Consumers
Power
Company

The proposed change (No 18) will enable Consumers Power Company to insert into the reactor at Big Rock Point a fuel design, designated as "Modified E-G," which will permit the irradiation of four fuel bundles with up to 24 fuel rods with various mechanical properties, in removable rod positions in the fuel bundle. The purpose of the fuel rod irradiation tests, described herein, is to evaluate the irradiation-damage-induced mechanical property changes in zirconium-base alloy cladding as a function of alloy composition and fabrication method.

Request for Change to the Technical Specifications

License No DPR-6 ZEK

FIGURE 5.8 - BIG ROCK POINT "MODIFIED E-G" FUEL

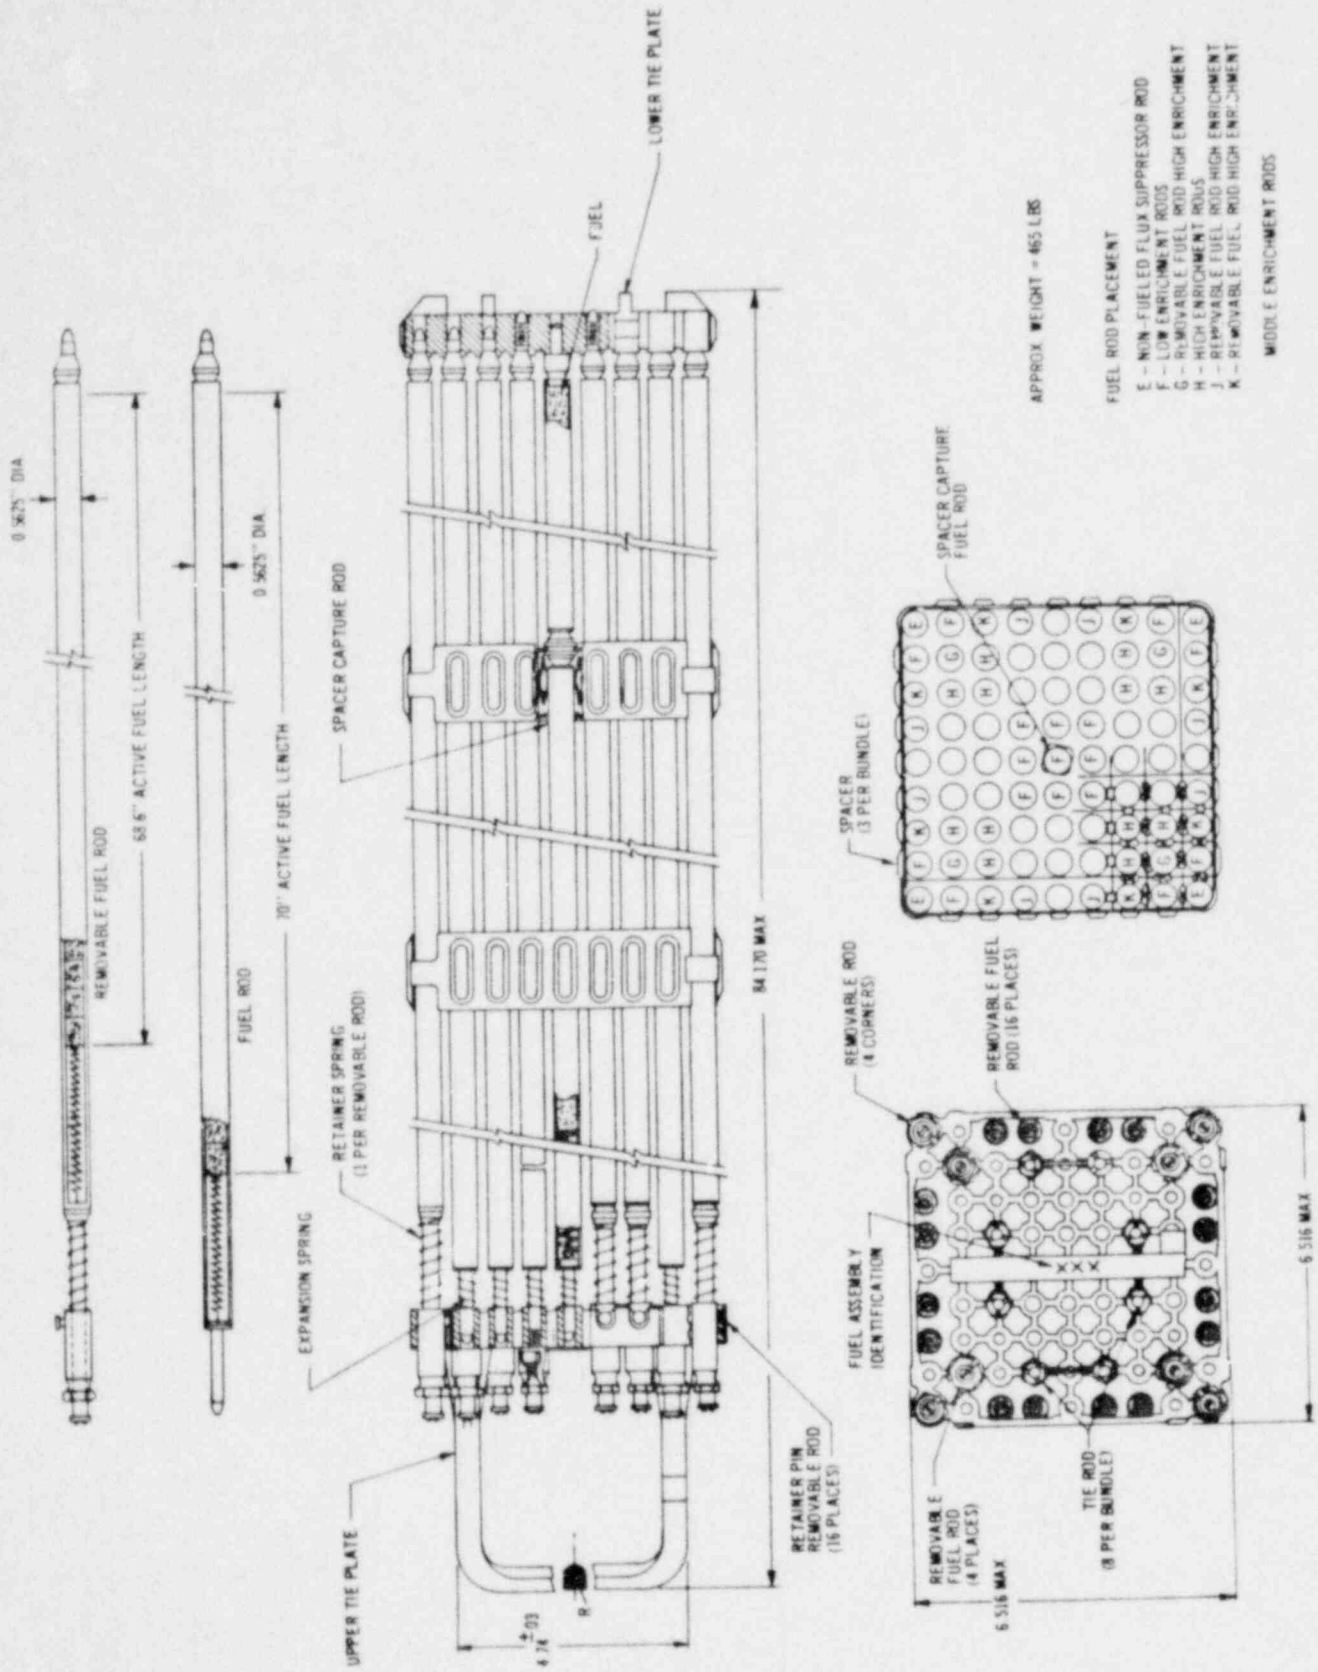
C. In Section 5.1.5, add Figure 5.8.

The four demonstration fuel bundles (Figure 5-8 - outline drawing) are physically the same as the Reload "E" and "E-G" fuel. Differences are summarized below:

- Modification of the Reload "E-G" mechanical design to include:

- Addition of 16 removable peripheral fuel rod positions;

- Use of four removable interior fuel rod positions;

- Use of four corner removable thermal neutron absorber rod positions for nonfuel samples.

Figure 1
Modified E-G Bundle
Location of Test Fuel Rods

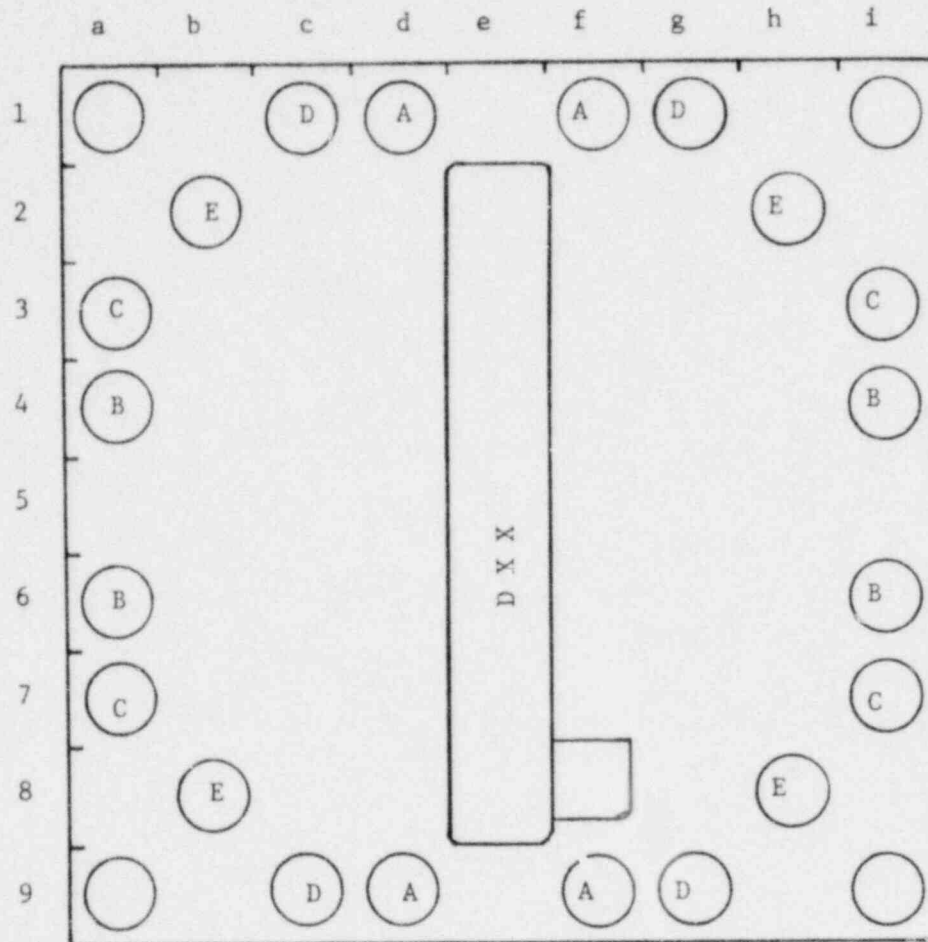
Four types of zirconium alloys (three are of basic Zr-2 with variations in thermomechanical processing; the fourth type being the Zr- 3Nb- 1Sn alloy) would be incorporated into these fuel bundles along with normal Zr-2 fuel rod cladding.

Figure 1 summarizes the proposed test matrix and position of the test fuel rods within the bundle.
